Subject: Environmental Report for the EREF; Supplemental Information – EREF 161-KV  
Transmission Line (ER RAI #4 - Revised Response)

**ER RAI #4 – Revised Response**

**Text of NRC RAI Number:** ER RAI 4.a

EREF Transmission Line  
Resource Summary Poster  
Figure 1, Sheet 1

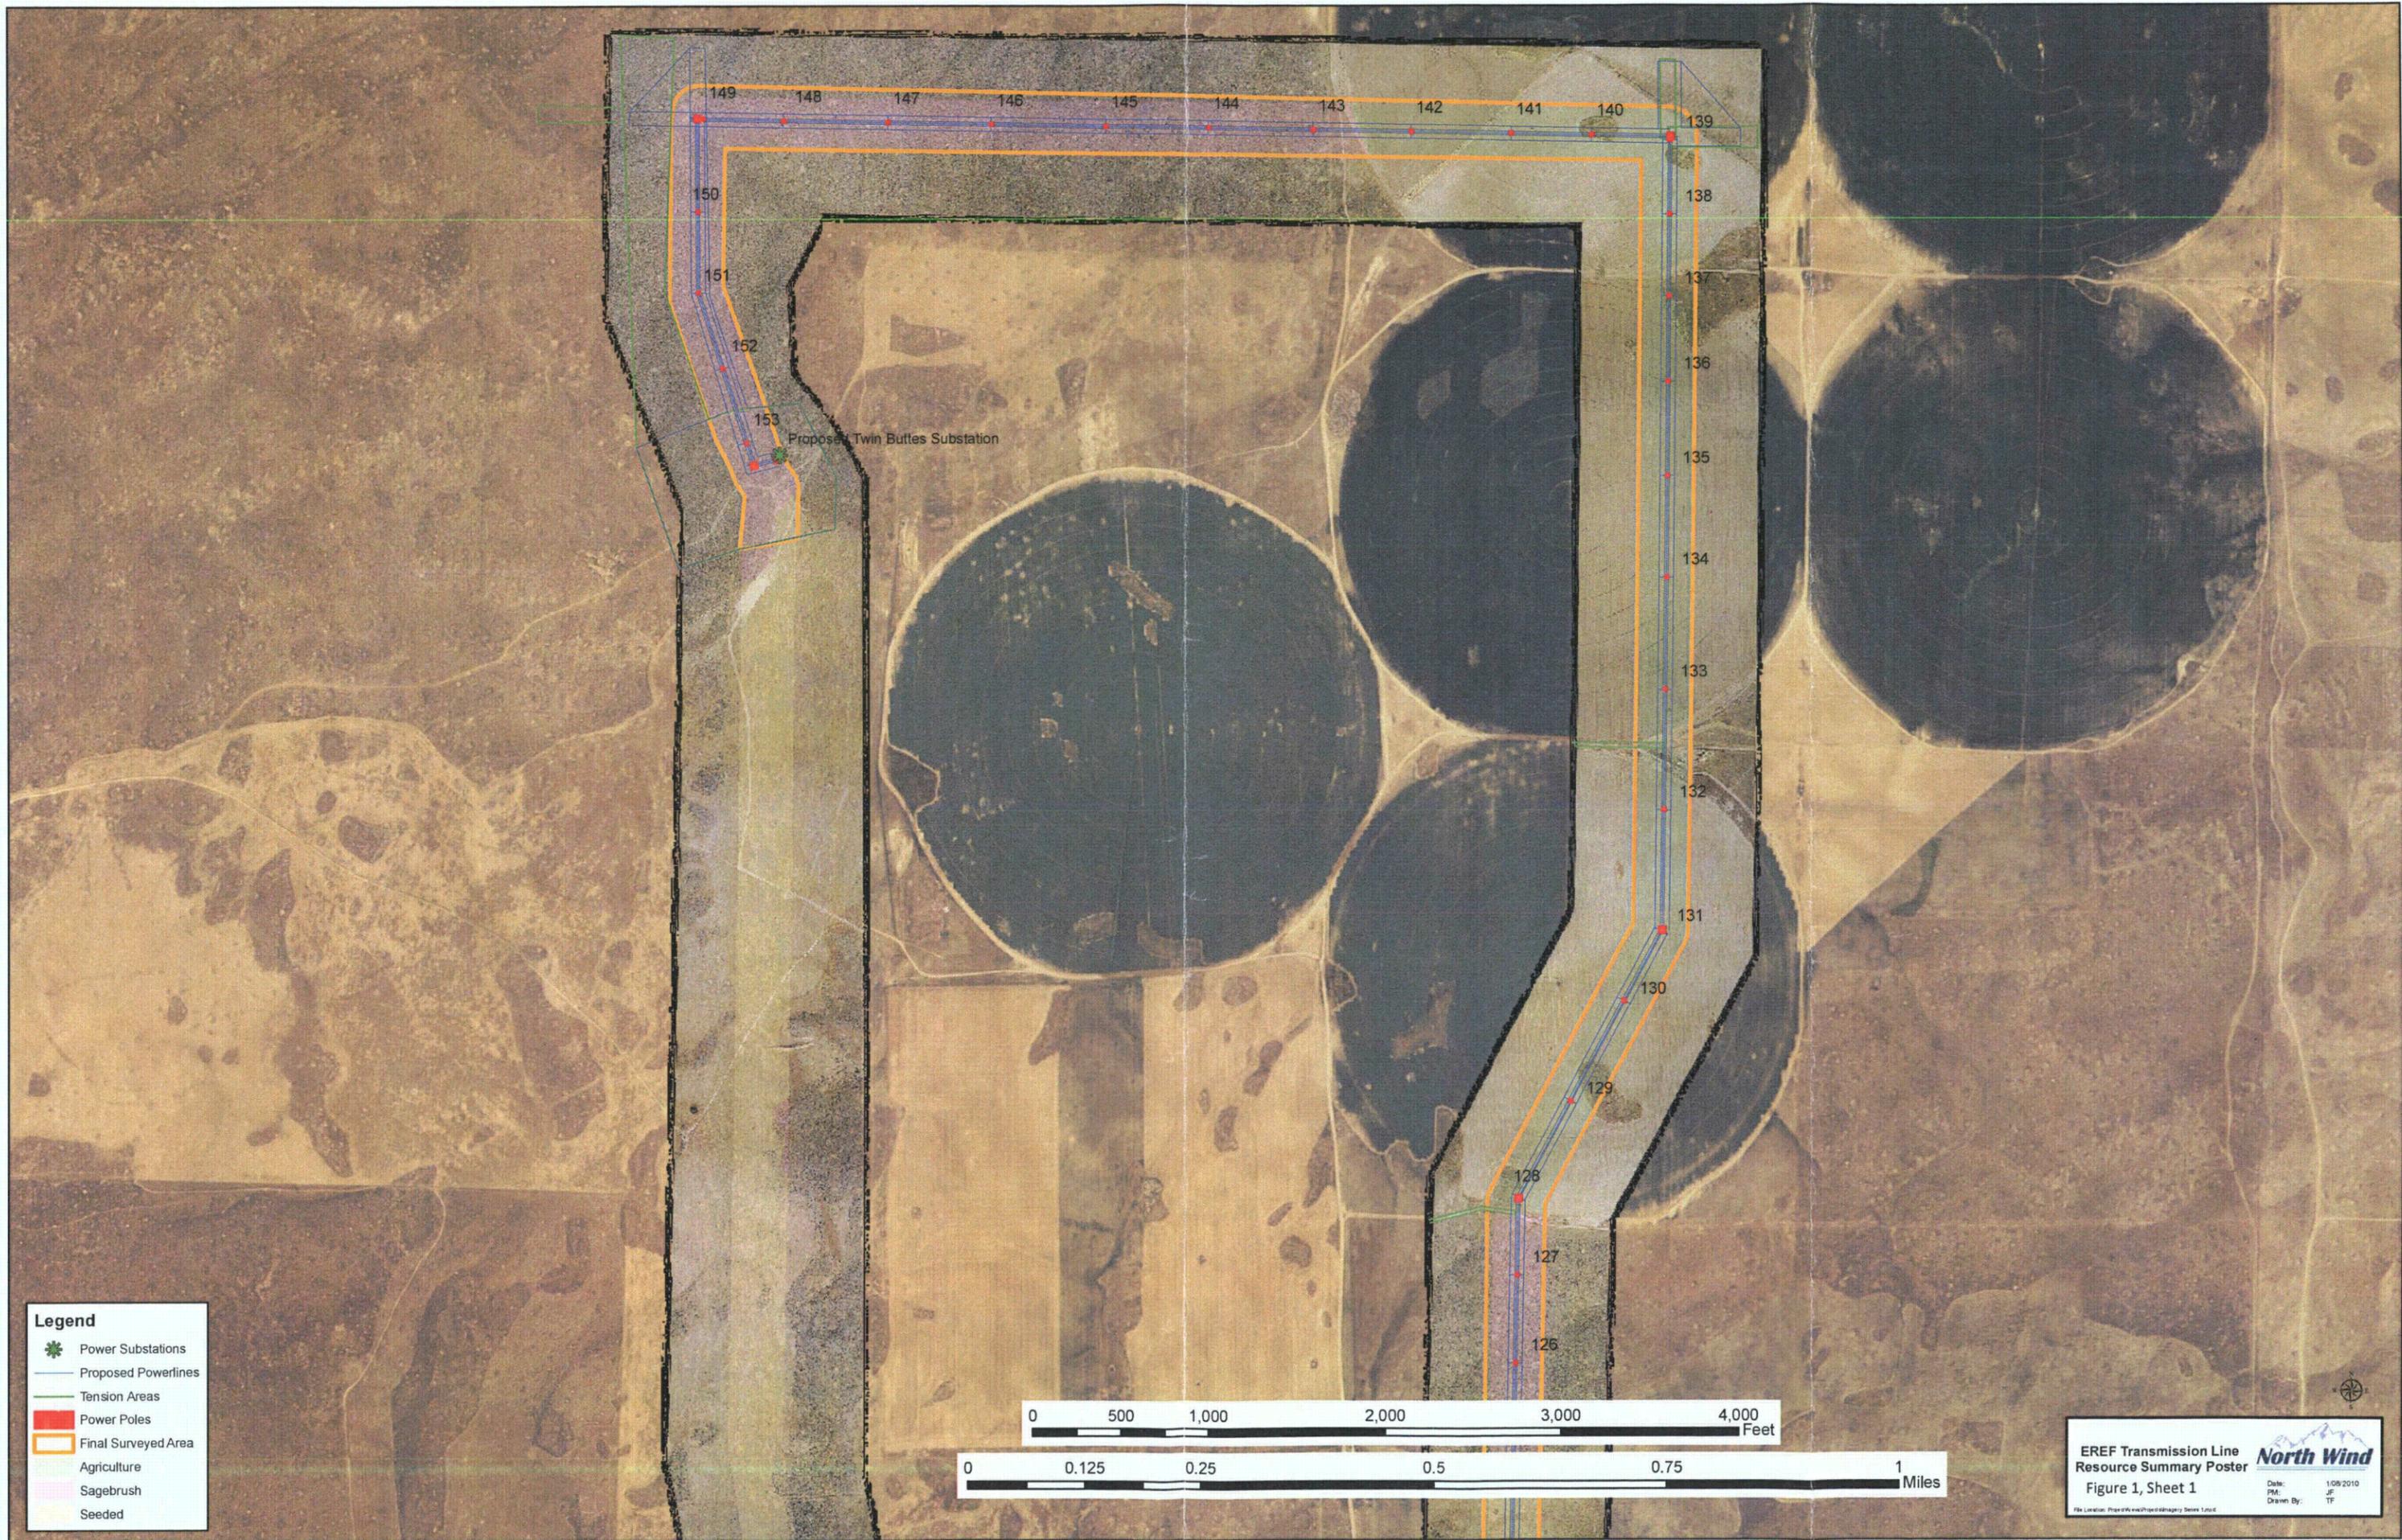
**Provide additional information regarding the analysis performed to locate the proposed electrical transmission lines for EREF site power consumption.**

- a. Provide a copy of the Rocky Mountain Power conceptual study report (December 2008) that describes potential facility access to the electric grid (transmission line options) as identified during the NRC site visit in June.

Section 4.1.2 (AES 2009a) described land use considerations, but did not provide a basis for the locations of the proposed transmission lines. This information is needed to assess the construction and operation cumulative impacts of the proposed EREF.

Potential Effect (previously surveyed for the EREF). Access to existing farm roads on the EREF property are shown at structures 132 and 128. Refer to Figure 1, sheet 1. One new access road will be a two track access road (dirt road) from the existing dirt farm road on the EREF property to structure 116 on the EREF property. Refer to Figure 1, sheets 2 and 3.
